Mobile Intel® Pentium® 4 Processor-M

Specification Update

January 2006

Document Number: 250721-032

Figure 13. System Bus Reset and Configuration Timings

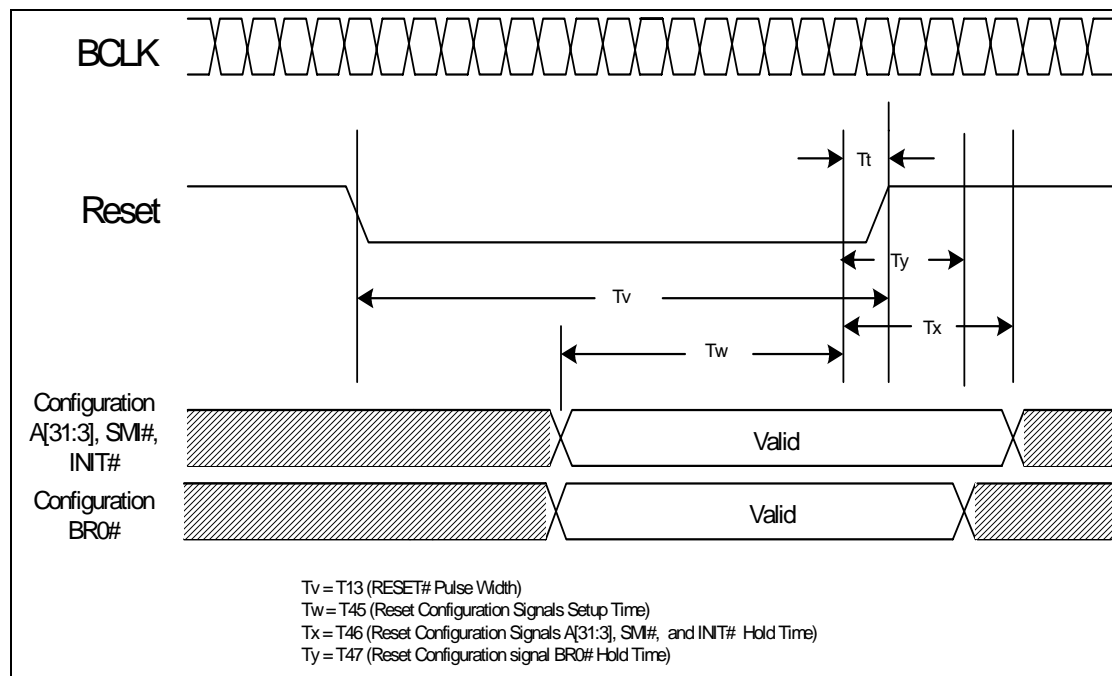
T2. BR0# Maximum Hold Time Specification Change

The BR0# maximum hold time has changed to 2 BCLKs. This change will be shown in the “System Bus AC Specifications (Reset Conditions)” table and “System Bus Reset and Configuration Timings” figure of the *Mobile Intel® Pentium® 4 Processor - M Datasheet*. This change will be incorporated in the next revision of the datasheet.

The following figure will be modified to reflect this change:

T# Parameter	Min	Max	Unit	Figure	Notes
T45: Reset Configuration Signals (A[31:3]#, BR0# INIT#, SMI#) Setup Time	4		BCLKs	13	1
T46: Reset Configuration Signals (A[31:3]#, INIT#, SMI#) Hold Time	2	20	BCLKs	13	2
T47: Reset Configuration Signal BR0# Hold Time	2	2	BCLKs	13	2
